工程指示 / 要求簡箋(E.I.)

工程名稱：將軍澳日出康城 11

工程項目：幕牆 單元件 地盆顧問報告

附上報地盆顧問報告

Photo 6

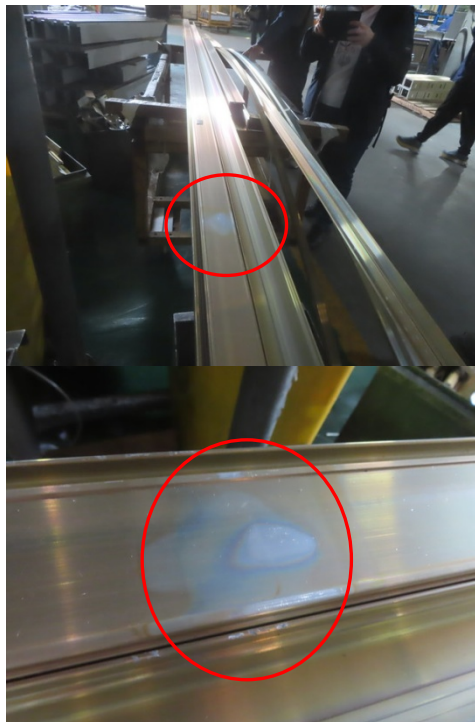
Description:
Defective chrome plated finishing for gutter sleeve was found during factory inspection

Action:
- MIDI is required to carry out their internal QA/QC method to repair the defective chrome plate finishing and improve workmanship for future works

Photo 10

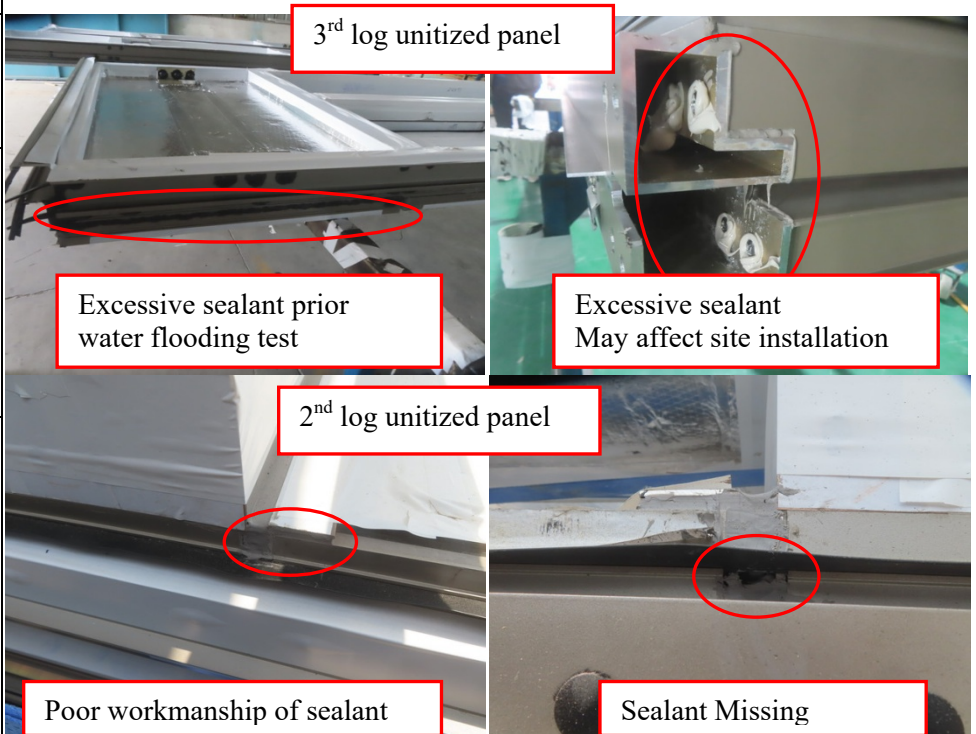
Description:
Defective sealant for 2nd & 3rd log unitized panels were found during final inspection and packing

Action:
- MIDI is reminded to carry out the remedial works prior products delivery and to improve workmanship for future works

廠方注意：
提升打膠
質量
